UNITED STATES PATENT AND TRADEMARK OFFICE

APPLICATION NO.	FILING DATE	FIRST NAMED INVENTOR	ATTORNEY DOCKET NO.	CONFIRMATION NO.
10/578,642	05/09/2006	Pieter Jan Mark Smidt	NL 031337	1733
24737	7590	10/01/2007	EXAMINER	
PHILIPS INTELLECTUAL PROPERTY & STANDARDS			VU, BAO Q	
P.O. BOX 3001			ART UNIT	PAPER NUMBER
BRIARCLIFF MANOR, NY 10510			2838	
MAIL DATE		DELIVERY MODE		
10/01/2007		PAPER

DETAILED ACTION

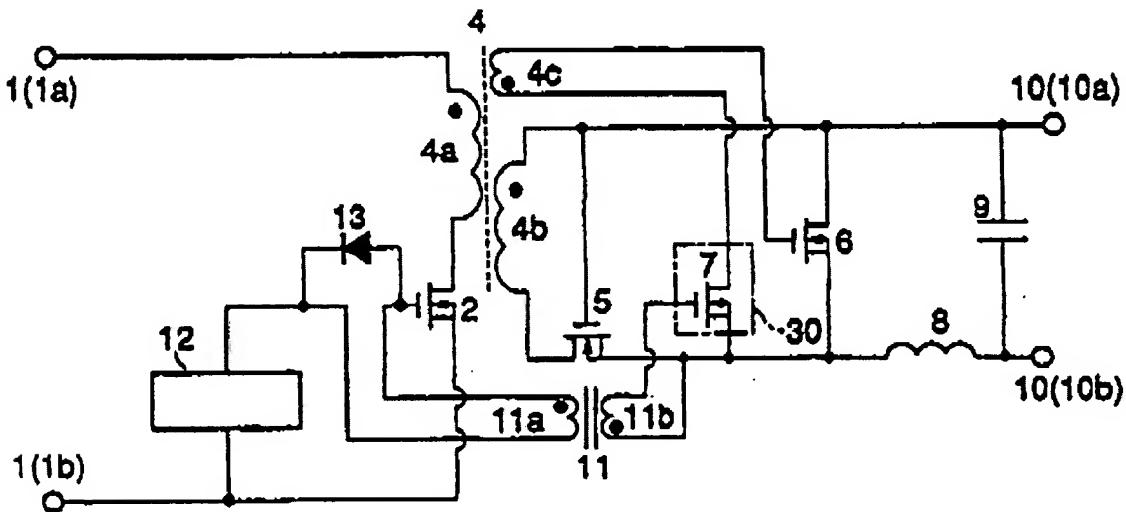
2. The drawings are objected to because the blank boxes 14, 17, 24 and 27. Please insert a short descriptive label for these blank boxes. Corrected drawing sheets in compliance with 37 CFR 1.121(d) are required in reply to the Office action to avoid abandonment of the application. Any amended replacement-drawing sheet should include all of the figures appearing on the immediate prior version of the sheet, even if only one figure is being amended. The figure or figure number of an amended drawing should not be labeled as "amended." If a drawing figure is to be canceled, the appropriate figure must be removed from the replacement sheet, and where necessary, the remaining figures must be renumbered and appropriate changes made to the brief description of the several views of the drawings for consistency. Additional replacement sheets may be necessary to show the renumbering of the remaining figures. Each drawing sheet submitted after the filing date of an application must be labeled in the top margin as either "Replacement Sheet" or "New Sheet" pursuant to 37 CFR 1.121(d). If the examiner does not accept the changes, the applicant will be notified and informed of any required corrective action in the next Office action. The objection to the drawings will not be held in abeyance.
